APPROVED MEETING MINUTES

Northgate Station Garage

Schematic Design

Figure 2. Site plan for the north entry plaza from the October 2014 (above) and July 2015 presentations.

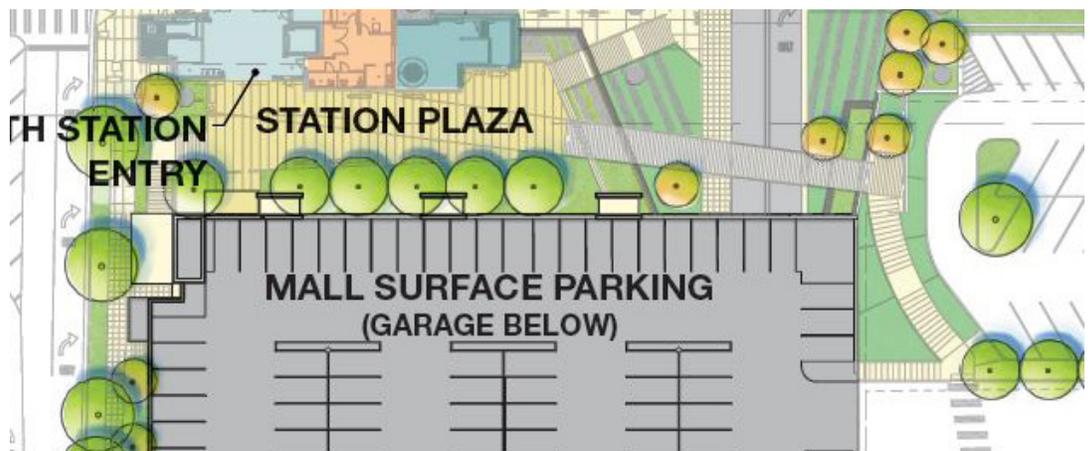
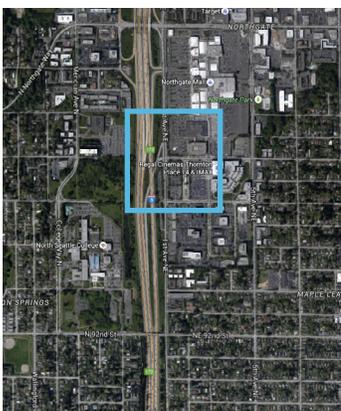
The LRRP first discussed the plaza and pedestrian circulation at the north entry plaza given the substantial design changes since the LRRP's concept design approval. The LRRP supported the decision to redesign the northern portion of the plaza and the addition of the pedestrian bridge, which Panel members found to be an exciting element of the design. LRRP encouraged the team to make the bridge design as light and transparent as possible to make it distinct from the garage and north plaza. The LRRP also recommended further exploration of whether the stair at the south end of the plaza could move to the west to create a more generous and welcoming landing space at NE 103rd Street adjacent to the elevator.

Figure 3. The proposed pedestrian bridge over the garage entrance is visible in this west elevation.

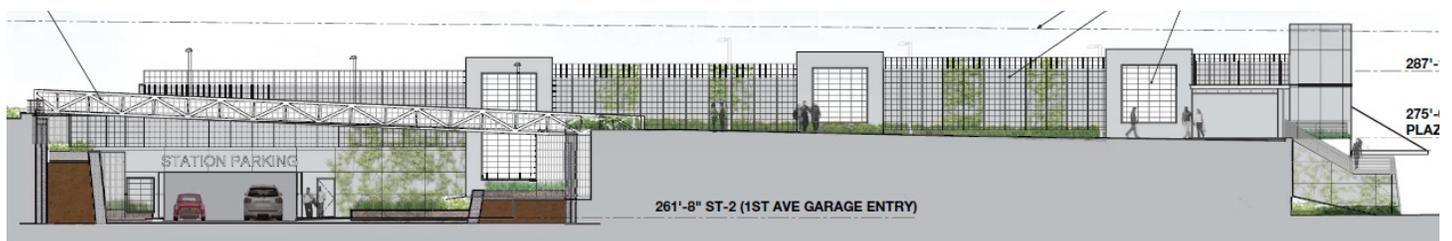
Finally, the LRRP considered the elevations and materials for the garage. They commended the design team for integrating the required vents into the garage design. The commission suggested updating the designs of the south-facing wall next to the NE 103rd Street stair landing adjacent to the elevator if the stair from the plaza to NE 103rd Street is moved to the west. The LRRP also recommended differentiation in materials between the plaza, the columns and guideway, and the bridge surface.

3. Design the pedestrian bridge to appear light and transparent.
4. Incorporate methods to slow vehicles entering and exiting the garage along 1st Avenue NE, including visual and/or tactile ground-plane treatments.

Figure 4. The LRRP suggested moving the stair to the west (A) and refining the relationship among the canopy, plaza, and garage (B)

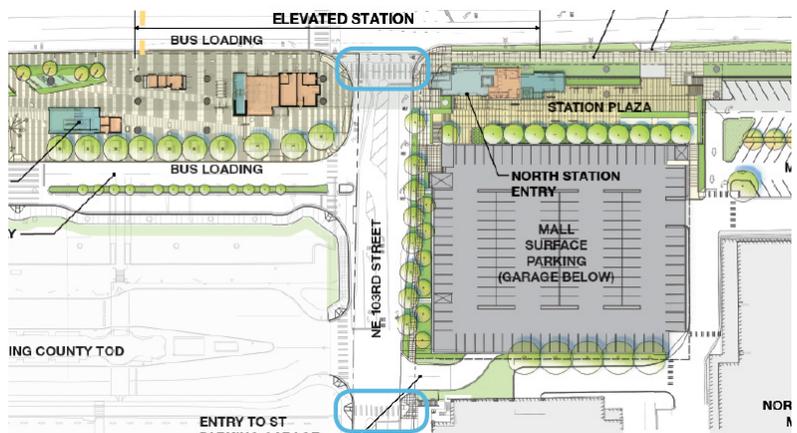
1. Consider moving the south stair to the west to expand the landing space at NE 103rd St adjacent to the elevator (**Figure 4**).
2. Continue to study whether the crosswalk along NE 103rd Street, shown in **Figure 5**, should be perpendicular to the sidewalk rather than angled.

6. Emphasize the use of planting at the entrance to the plaza from 1st Avenue NE (**Figure 6**).
7. Consider raising the elevator canopy at NE 103rd Street to align with the edge of the plaza, particularly if the stair accessing the elevated plaza moves west.
